**Final Initial Study/Mitigated Negative Declaration
Stonebridge Subdivision Project
2220 Fulton Road
City of Santa Rosa, California**

State Clearinghouse Number: 2020059046

Date: April 20, 2021

Page 68, Exhibit 11a and Exhibit 11b

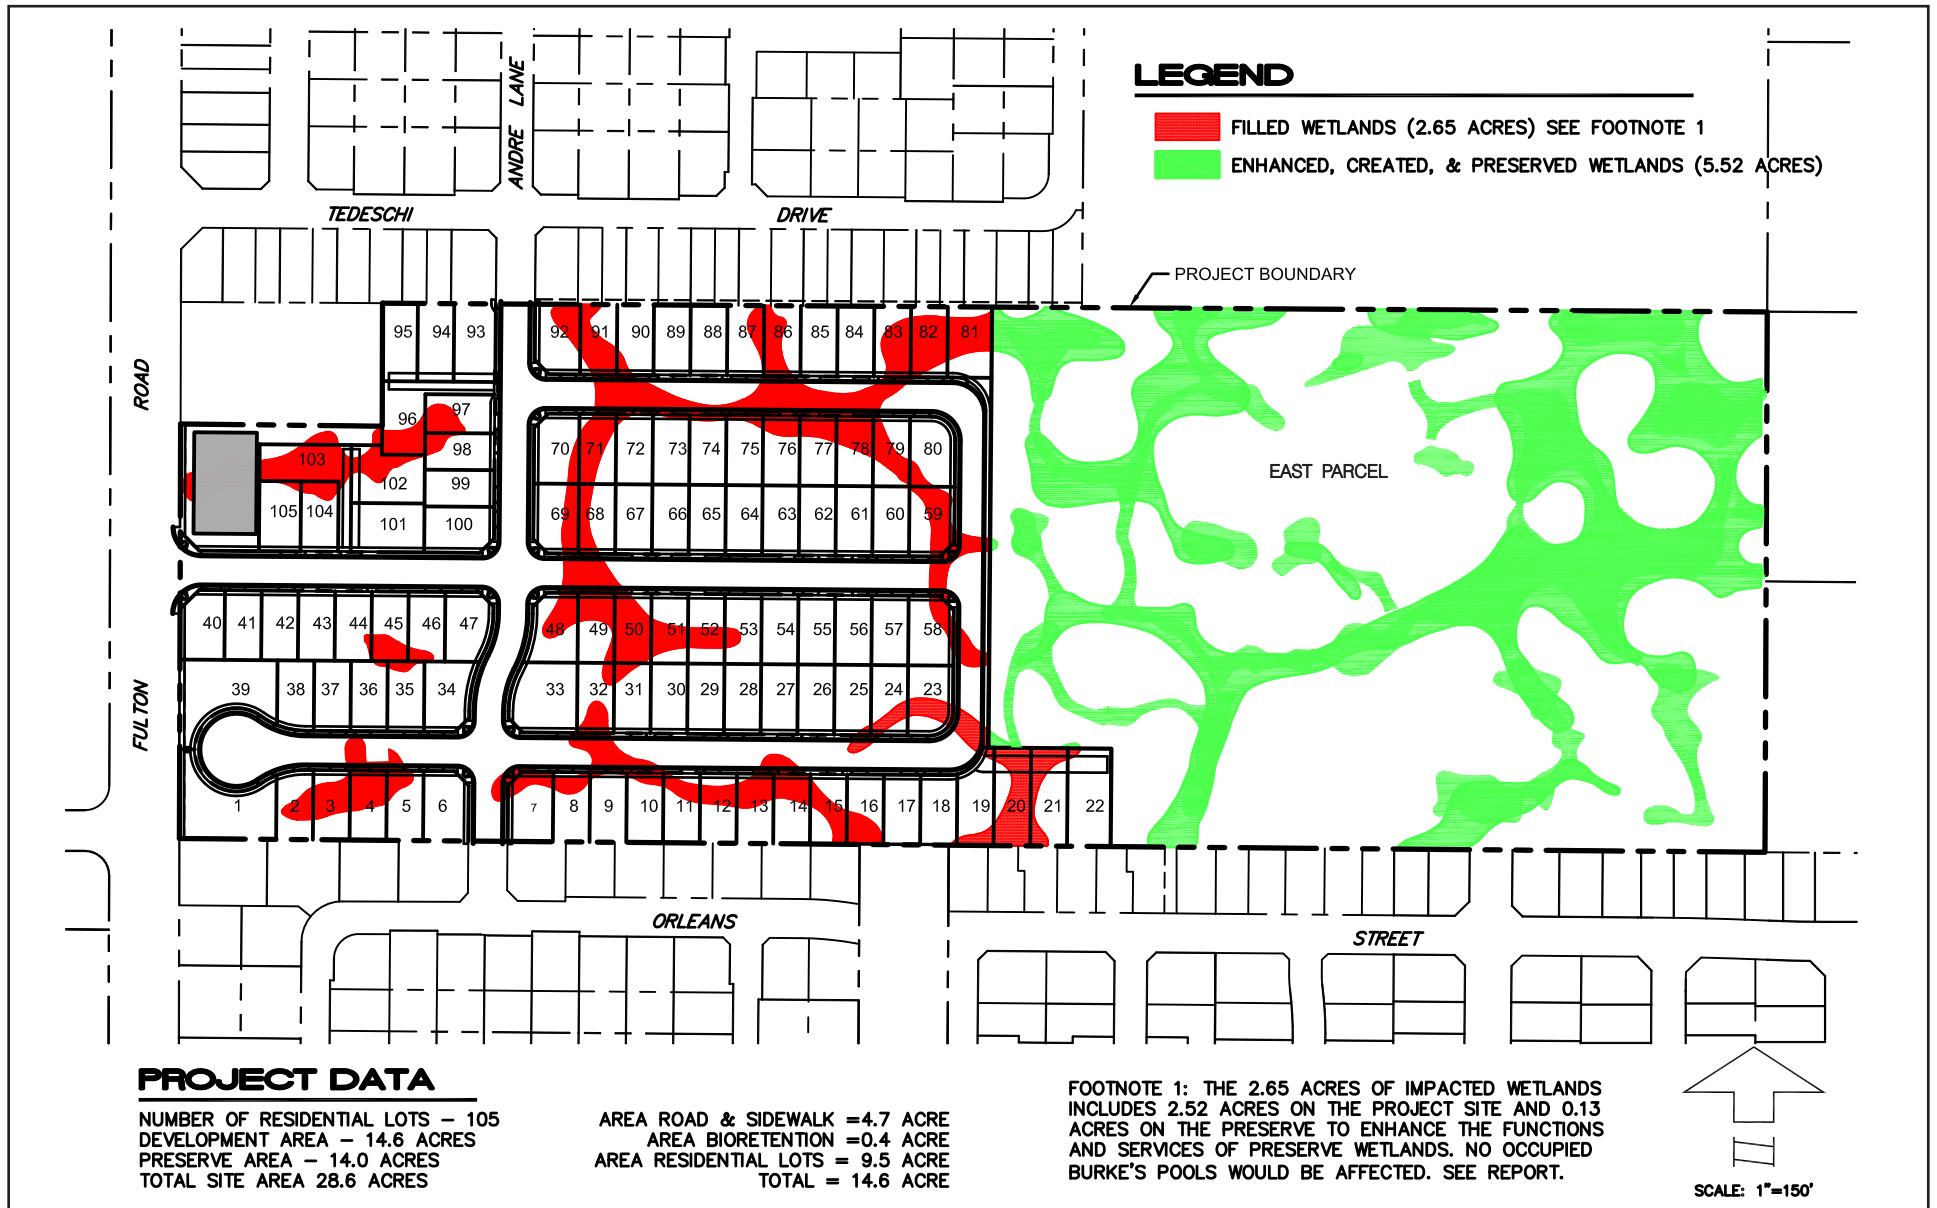
Issue: According to the MND Appendix B Biological Resources Analysis, the Project would impact 2.65 acres of vernal pool habitat which includes Lobb's buttercup (*Ranunculus lobbii*), a special-status plant as it has a California Rare Plant Rank of 4.2. The MND analyzes the permanent removal of 2.65 acres of wetlands but does not analyze the temporary disturbance to 3.267 acres of wetlands on the East Parcel which also may support Lobb's buttercup.

Specific impacts and why they would occur: The Project's residential construction activities would remove up to 2.52 acres of Lobb's buttercup habitat, and habitat enhancement activities would remove an additional 0.13 acres, for a total of up to 2.65 acres of permanent habitat loss. It would also temporarily impact 3.267 acres of the habitat from habitat enhancement-related recontouring activities.

Collection of Lobb's buttercup seed has been added to MM BIO-1d as shown below and is also included in Section 3, Errata, of the Final IS/MND. In addition, Exhibit 11 has been split into two exhibits, Exhibit 11a: Wetland Impacts and Preservation, and Exhibit 11b: Proposed Wetland Enhancement and Creation. Both exhibits are included as part of Section 3, Errata, of the Final IS/MND.

To denote that Exhibit 11 in the Draft IS/MND was split into Exhibit 11a and Exhibit 11b, the following paragraph was revised.

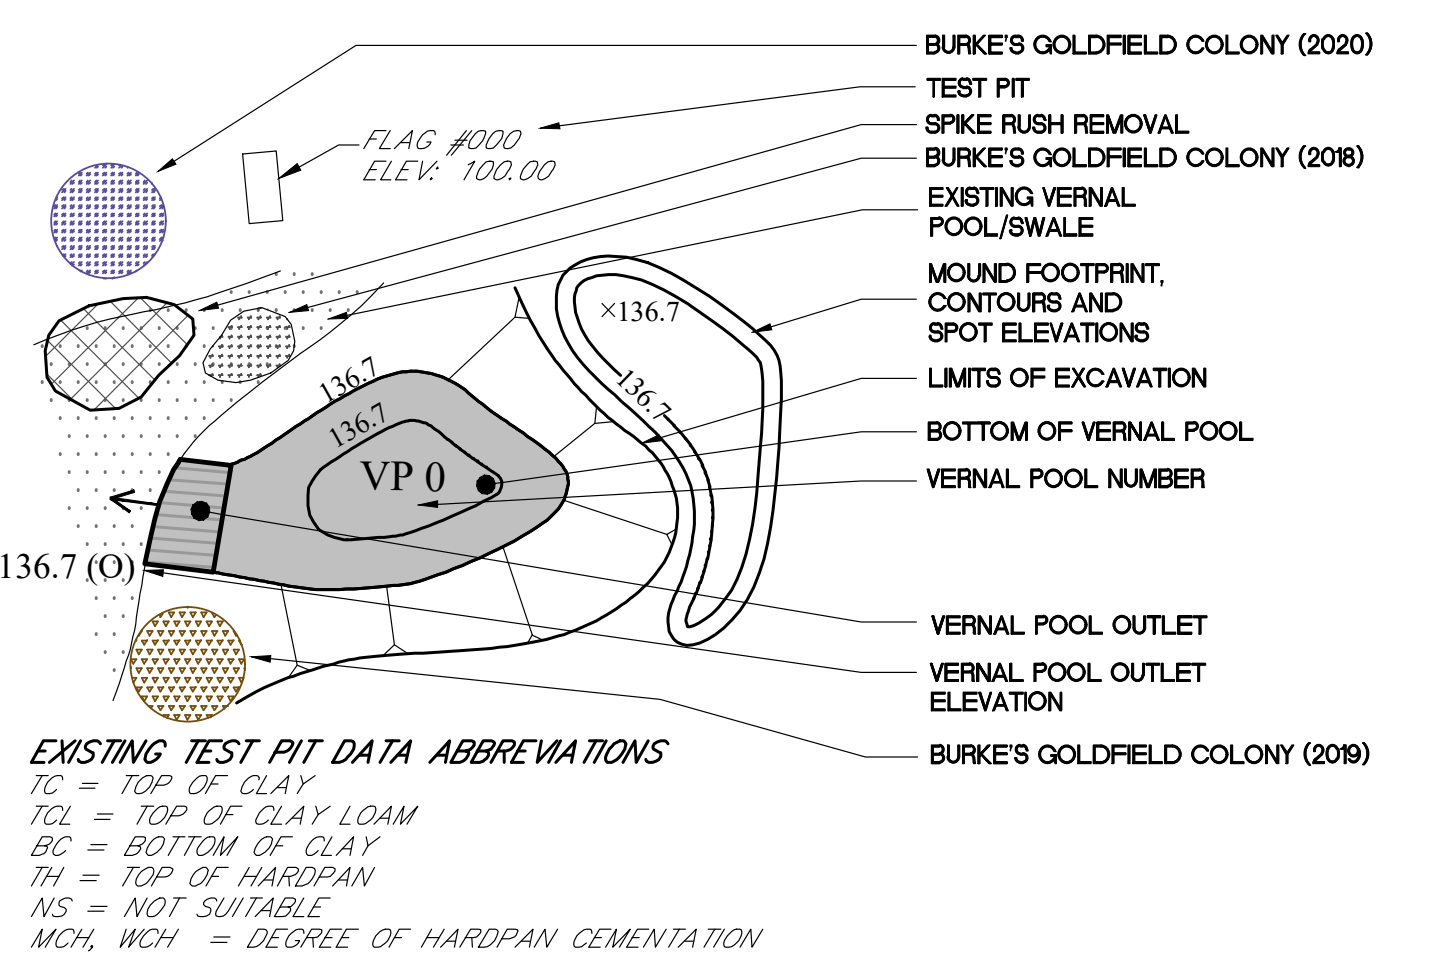
The MND should clarify if Project activities on the East Parcel would result in impacts to Burke’s goldfields. It states that impacts would be avoided; however, MND Appendix B Biological Resources Analysis Figure 6 shows occupied Burke’s goldfields habitat within the majority of East Parcel’s wetlands. Therefore, it is unclear how impacts from the proposed enhancement activities, such as recontouring, would avoid impacts. If such activities would result in impacts to Burke’s goldfields either directly or indirectly, through for example hydrological modification, either on or adjacent to the Project area, an ITP or other CDFW authorization may be more appropriate for the Project. Adjacent habitat includes the CDFW-owned Woodbridge Preserve which supports a sensitive Burke’s goldfields population.

- 1) Clearly show on aerial based mapping where and what types of wetland enhancement activities would occur in relation to occupied Burke’s goldfields habitat and the CDFW Woodbridge Preserve;
- 2) Provide additional analysis demonstrating that Burke’s goldfields will be avoided;
- 3) Require coordination with CDFW prior to conducting wetland enhancement activities to ensure impacts to Woodbridge Preserve are avoided; and,

THE EXISTING BURKES GOLDFIELD PLANTS IN THIS AREA WILL NOT BE DISTURBED BY WETLAND CREATION OF VERNAL POOL 56. THE HYDROLOGIC CONDITIONS WILL REMAIN THE SAME AS BEFORE CONSTRUCTION. THE WATER BEING CONSTRUCTED WILL MAINTAIN THE CURRENT WATER LEVELS IN THIS AREA.
EXISTING WATER SURFACE 137.1, PROPOSED WATER SURFACE 137.2

THE EXISTING BURKES GOLDFIELD PLANTS IN THIS AREA WILL NOT BE DISTURBED BY WETLAND CREATION OF VERNAL POOL 30. THE HYDROLOGIC CONDITIONS WILL REMAIN THE SAME AS BEFORE CONSTRUCTION.

THE EXISTING BURKES GOLDFIELD PLANTS IN THIS AREA WILL NOT BE DISTURBED BY WETLAND CREATION OF VERNAL POOL 56. THE HYDROLOGIC CONDITIONS WILL REMAIN THE SAME AS BEFORE CONSTRUCTION. EXISTING WATER SURFACE 137.5, PROPOSED WATER SURFACE 137.5

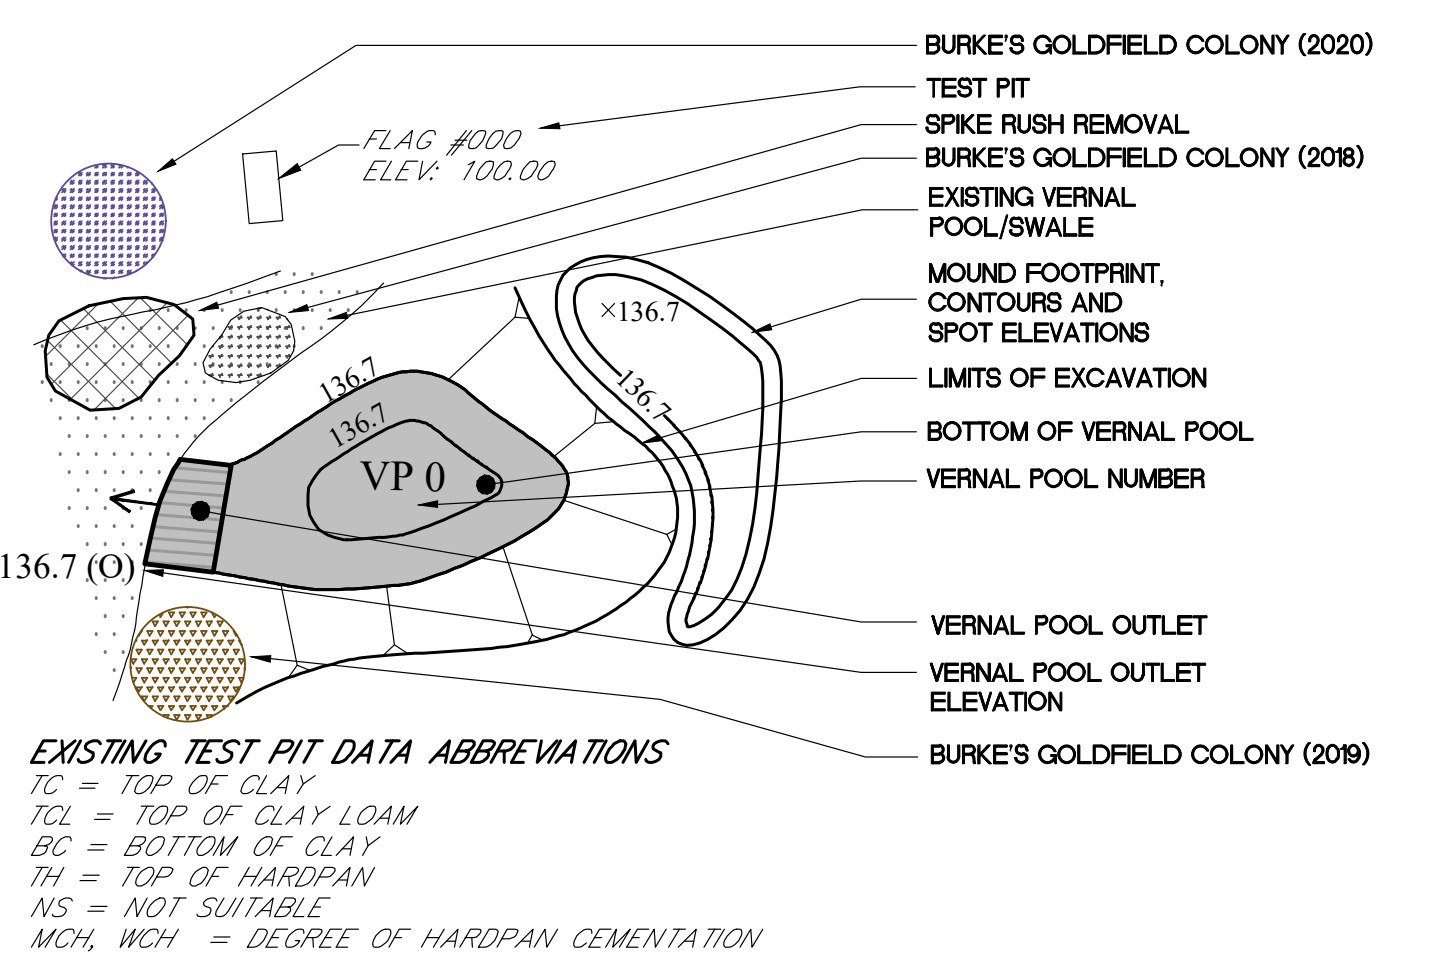
The agency recommends that the IS/MND clarify whether project activities on the East Parcel would result in impacts on Burke's goldfields, and says it is unclear how impacts from enhancement activities, such as recontouring, would avoid impacts. The agency also notes that if project activities would result in impacts on Burke's goldfields, either directly or indirectly through hydrological modification, for example, either on or adjacent to the project area, then an ITP or other CDFW authorization may be more appropriate for the proposed project. Finally, the commenter notes that adjacent habitat includes the CDFW-owned Woodbridge Preserve which supports a sensitive Burke's goldfields population.

THE EXISTING BURKES GOLDFIELD PLANTS IN THIS AREA WILL NOT BE DISTURBED BY WETLAND CREATION OF VERNAL POOL 56. THE HYDROLOGIC CONDITIONS WILL REMAIN THE SAME AS BEFORE CONSTRUCTION. THE WATER BEING CONSTRUCTED WILL MAINTAIN THE CURRENT WATER LEVELS IN THIS AREA.
EXISTING WATER SURFACE 137.1, PROPOSED WATER SURFACE 137.2

THE EXISTING BURKES GOLDFIELD PLANTS IN THIS AREA WILL NOT BE DISTURBED BY WETLAND CREATION OF VERNAL POOL 30. THE HYDROLOGIC CONDITIONS WILL REMAIN THE SAME AS BEFORE CONSTRUCTION.

THE EXISTING BURKES GOLDFIELD PLANTS IN THIS AREA WILL NOT BE DISTURBED BY WETLAND CREATION OF VERNAL POOL 56. THE HYDROLOGIC CONDITIONS WILL REMAIN THE SAME AS BEFORE CONSTRUCTION. EXISTING WATER SURFACE 137.5, PROPOSED WATER SURFACE 137.5
